## Village Board Meeting Notice and Agenda

Monday, Oct. 12, 2020 – 6:30 pm  
Sherwood Village Hall – W482 Clifton Rd., Sherwood, WI.

**RE: PUD Development at High Cliff Golf Course Plan Review – 2<sup>nd</sup> Review**

**REGARDING:** PUD Development at High Cliff Golf Course  
Plan Review - 2nd Review

2. Drawing C5.1 :

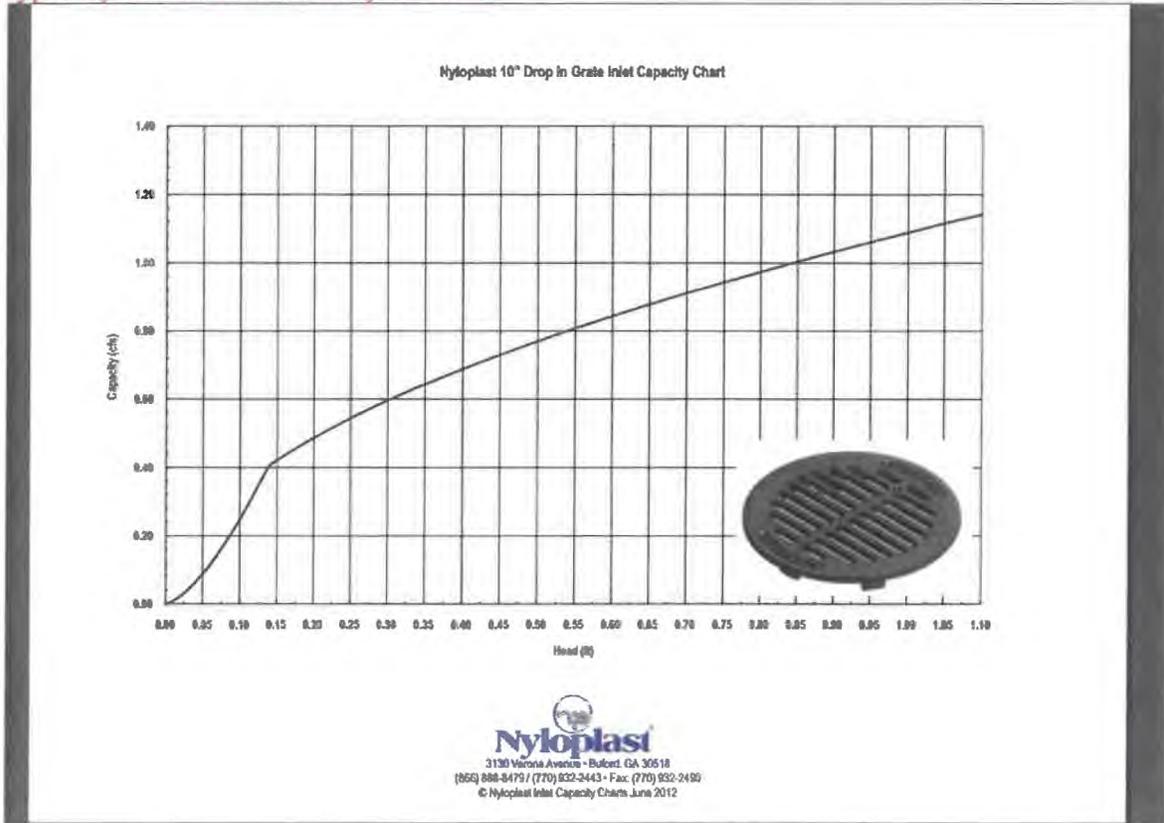
a. The typical section pavement mixes should be updated to today's standards for Detail 2.

b. Provide a callout for shoulder gravel size for Detail 1.

c. Detail 6 specifies heavy riprap. Please confirm if heavy rip rap is to be installed in all locations or if additional size details/notes are needed. Also confirm the length dimensioning shown so that it correlates with what is shown on the Drawings.

d. How will inlet protection devices be installed in the "revised" yard drain detail provided with this submittal? Provide an inlet capacity analysis review to confirm storm water runoff will not pond at each of these locations.

Revised

Revised

Plans revised to require Type A inlet protection around all inlets. Based on the storm sizing calculations, the worst case inlet is BI, which has a design flow into the inlet of 0.6 cfs. Below is the inlet capacity chart for the specified grate cover. At 0.6 cfs we would be looking at 0.3' of head in a rear yard swale which is acceptable. Most of the modeled grates will be receiving closer to 0.2 or 0.3 cfs of flow, which would be around 0.1' to 0.15' of head. The road is typically 0.7' above the front yard inlets.
